Strategic Infrastructure, Planning & Construction

DATE: May 27, 2025
TO: Potential Respondents
FROM: Carrie Stoeckert—Construction Contract Expeditor III
SUBJECT: Highlighted Revisions to Questions #1
RFCSP752-25-1005CS
Kerr Dining Hall Renovation

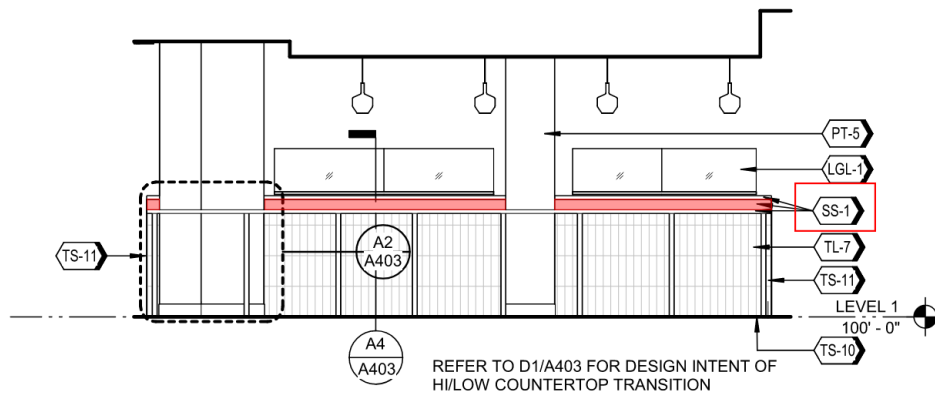
14. Demolition General Note R on sheet AD101 indicates to sawcut and remove portions of concrete floor slab for installation of underfloor plumbing lines, and for installation of recessed slab at walk-in cooler and freezer, and replace/patch back slab following installation of those items. Please

provide structural floor plan and details showing the extent of this work. Please provide information regarding the existing foundation slab.

ANSWER: Note is incorrect and will be removed in upcoming Addendum. Modification of structure in any way is not required. Any plumbing line installation will involve poke-through penetrations and not sawcutting/removal of portions of the concrete floor. Walk-in cold storage assembly does not require slab recess. Kitchen floor finish should extend flush into walk-in cold storage with a smooth, level threshold with the finish floor.

INTERIOR ELEVATION - HI/LOW AT BAR HEIGHT C2
1/4" = 1'-0"

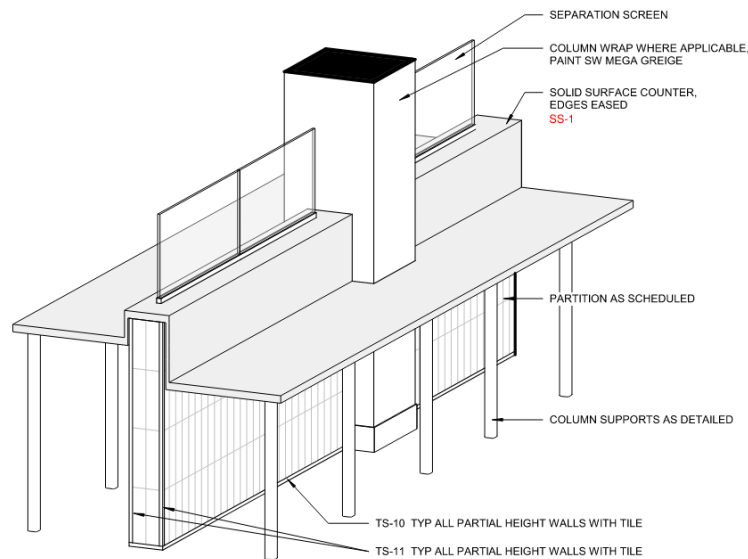
15. Please verify that the dining bar to counter in detail A1/A403 is to be SS-1 solid surface.

ANSWER: Confirmed. Countertop in detail A11/A403 is SS-1 solid surface.

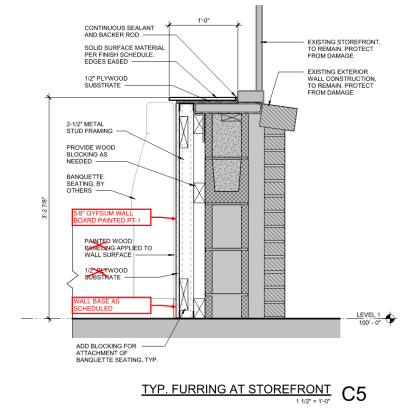
65. Detail A4/A403 please clarify if continuous HSS tube steel is required above the two HSS 3x3x3/16 at the centerline of the columns? They are shown but not called out.

ANSWER: Yes, continuous HSS tube steel is required above the two HSS 3x3x3/16 members shown. Note will be updated in upcoming Addendum.

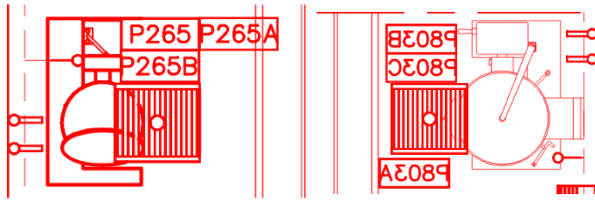
70. Items P265 and p803B on the food service plumbing schedule are incomplete. Please clarify what these items are specify their locations.

ANSWER: Refer to snapshot below for revised plumbing schedule and snapshots showing locations of each item.

P803A	3/4"	NATURAL GAS	KETTLE 60 GALLON	WALL	18"	BTC: 150 MBTU/HR
P803B	3/4"	HOT & COLD WATER	KETTLE	WALL	24"	BTC:
P803C	4"	HUB DRAIN	TRENCH LINER	FLOOR	-9"	BTC, CRITICAL LOCATION
P265	4"	HUB DRAIN	KETTLE TRENCH LINER	FLOOR	-9"	BTC; CRITICAL LOCATION
P265A	3/4"	H & C WATER	KETTLE	WALL	13"	BTC
P265B	3/4"	NATURAL GAS	KETTLE	WALL	18"	BTC: 100MBTU/HR

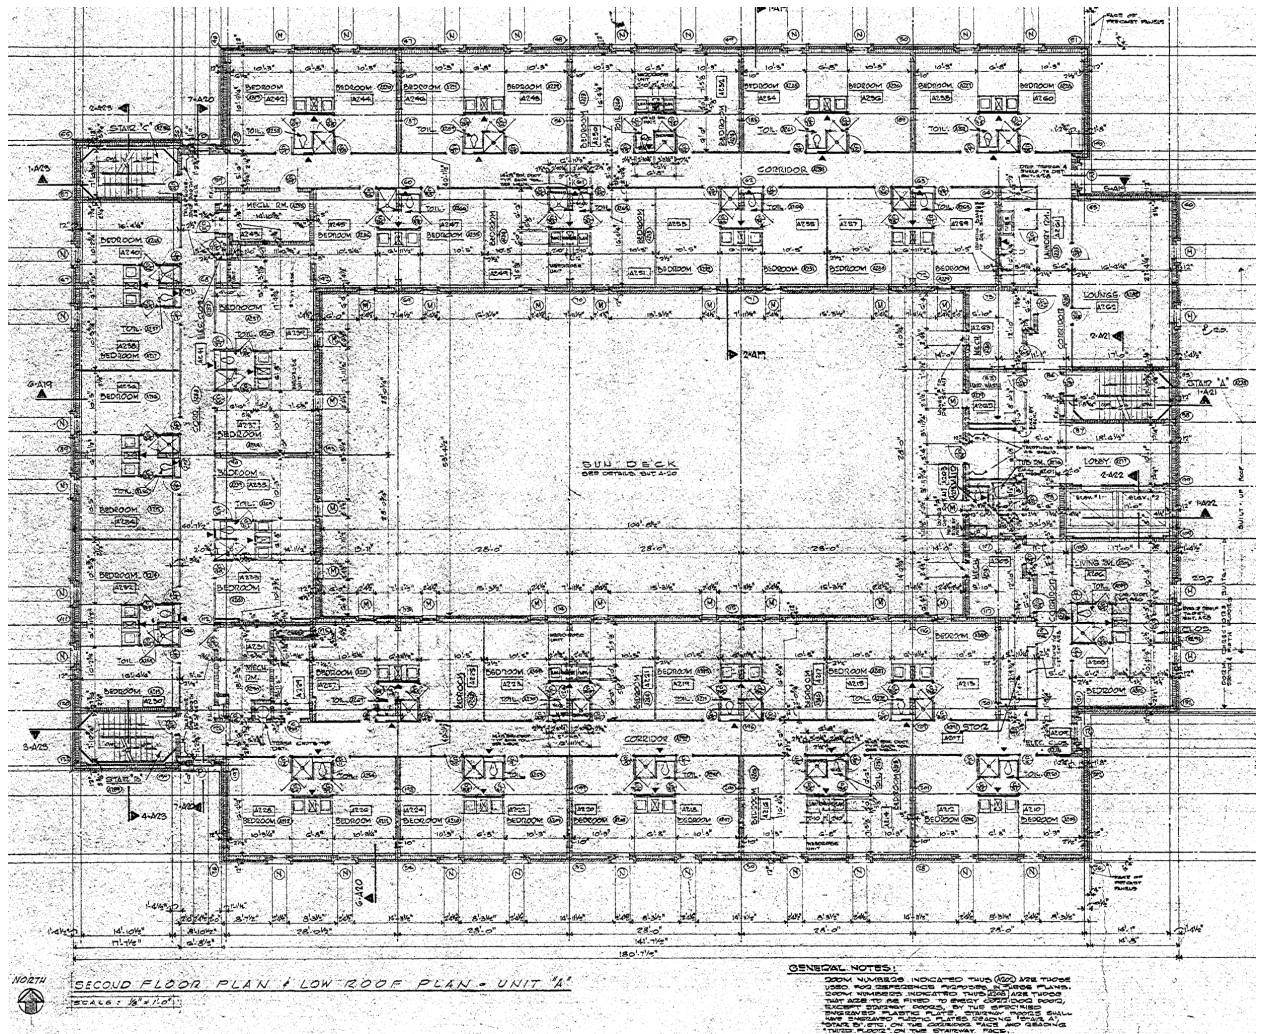
84. Please provide level 2 floor plan drawings and slab on grade details or crawlspace drawings. Please provide section cuts of floor to floor heights and transitions between floors.

ANSWER: **Floor-to-floor height is approximately 14'. Level 2 floor plan is below:**
